Land at Bird in Eye Farm
South of Bird in Eye Hill
Uckfield

PROOF OF EVIDENCE

Re: TRANSPORT MATTERS

Road Safety Audit Report

DRAWN BY	MB	DESIGN BY	-	CHK BY	MT
DATE	18/07/23	DRAWING No.	5330 / 033	REV No.	B
SCALE	1:500 @ A3

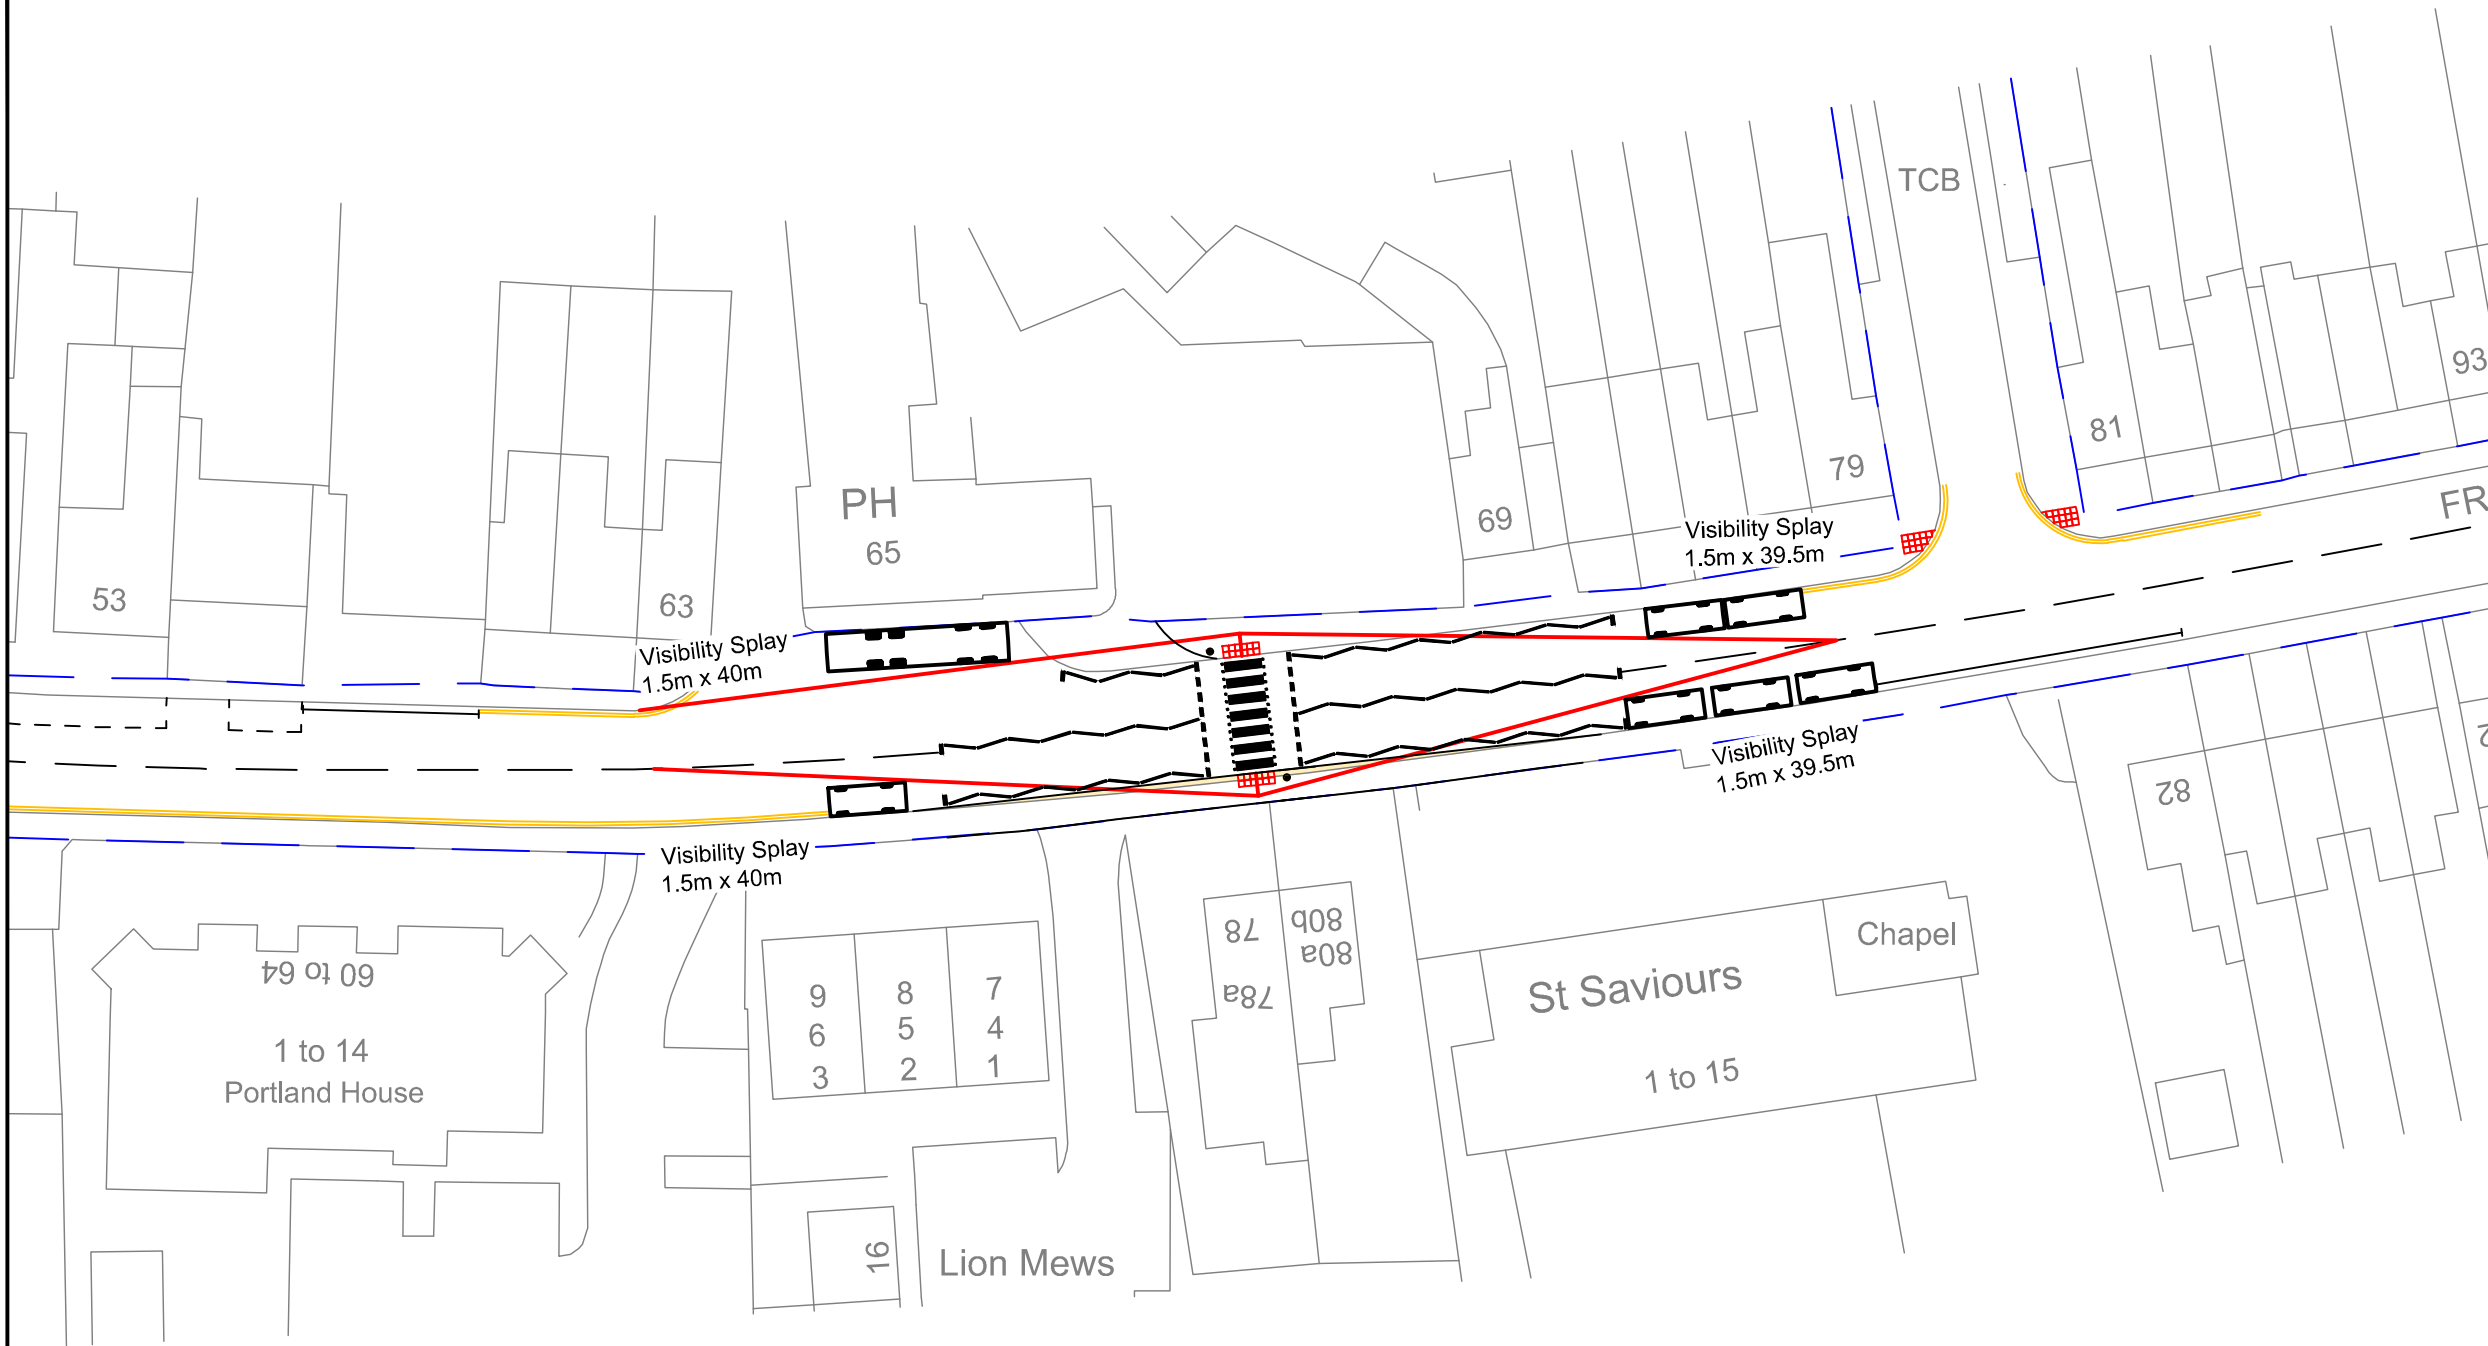
- 4) Driver visibility for peds and vice versa when considering the speeds; While the visibility splay quoted on the drawing meet the minimum requirements for the recorded 85%ile speed (just), the parking east of the crossing, on the north side of the road, has been conveniently displaced to facilitate this splay. This would not be the case in reality? To the west, the rigid truck (shown) would have to be parked tight to the kerb to not obstruct the splay (again- unlikely in reality).

- 5) Reducing the length of the zig zag marking on the north side of the road (west of the crossing) to get around the conflict of having a layby behind the zig zags (in the controlled area) is not the answer. This reduces the warning provided to an approaching driver at a crossing placement which offers the absolute (if that- see above) minimum visibility distances for pedestrians.

Thank you for your latest plans, drawings 5330-034 revision D and 5330-033 revision B illustrating the proposed zebra crossing along Framfield Road in Uckfield.
